# Access Compliance Report

## Public Rights-of-Way (Curb Ramps)

Intersection ID: 22250	Main Street: SHARON_LAKES_RD	Cross Street: SOUTH_BV	Location: NW
ADA ID: AC0656F49503	Ramp Type: Perp	Initial Pass/Fail: Fail	Overall Compliance: No Severity Score: 33.75

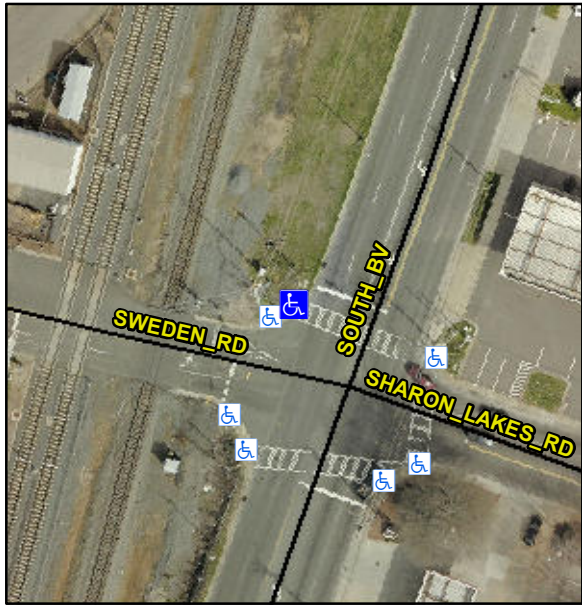
Codes/Mitigation Info/Possible Solution			Field Measurements/Component Compliance					
	Possible Solutions:		Compliance	Description	Data	Compliance	Description	Data
	Remove & Replace Entire Ramp.		N/A	Ramp Length (in)	48.0	No	Ramp Slope (%)	13.5
			No	Ramp Width (in)	39.5	Yes	Ramp XSlope (%)	1.9
			N/A	Flare Type LT	N/A	N/A	Flare Type RT	N/A
			N/A	Flare Slope LT (%)	N/A	N/A	Flare Slope RT (%)	N/A
			N/A	Flare Traversable LT?	N/A	N/A	Flare Traversable RT?	N/A
			N/A	Landing Length (in)	N/A	N/A	DWS Provided?	N/A
			N/A	Landing Width (in)	N/A	N/A	DWS Contrast?	N/A
			N/A	Landing Slope (%)	N/A	N/A	DWS Length (in)	N/A
			N/A	Landing X Slope (%)	N/A	N/A	DWS Full Width?	N/A
Surveyor Notes:	N/A		N/A	Landing Curb? (Y/N)	N/A	N/A	DWS Offset (in)	N/A
			N/A	Shared Landing?	N/A			
			N/A	Gutter Ponding?	N/A	N/A	Gutter Slope (%)	N/A
			N/A	Gutter Lip Ht (in)	N/A	N/A	Gutter X Slope (%)	N/A
			N/A	Painted X Walk1?	Yes	N/A	Painted X Walk2?	N/A

X Walk 1 Direction	To SE		X Walk 2 Direction	N/A
			N/A	X Walk 1 Width (in)	111.0	N/A	X Walk 2 Width (in)	N/A
				X Walk 1 Slope (%)	0.7		X Walk 2 Slope (%)	N/A
				X Walk 1 X Slope (%)	1.8		X Walk 2 X Slope (%)	N/A
			N/A	Ramp inside XWalk1?	Yes	N/A	Ramp inside XWalk2?	N/A
PROW/ADA:	Not Found, R304.5.1, R304.2.2			Road Slope (%)	N/A	N/A	Clear Space?	N/A
				Road X Slope (%)	N/A	N/A	Clear Space to XWalk (in)	N/A
			N/A	Any Obstructions?	N/A	N/A	Storm Grate/Utility Hazard?	N/A
				Obstruction Type			Storm Grate/Utility Type	
					N/A			N/A
						Yes	Surface Condition? (G/P)	Good
Total Cost:		\$ 1850.00
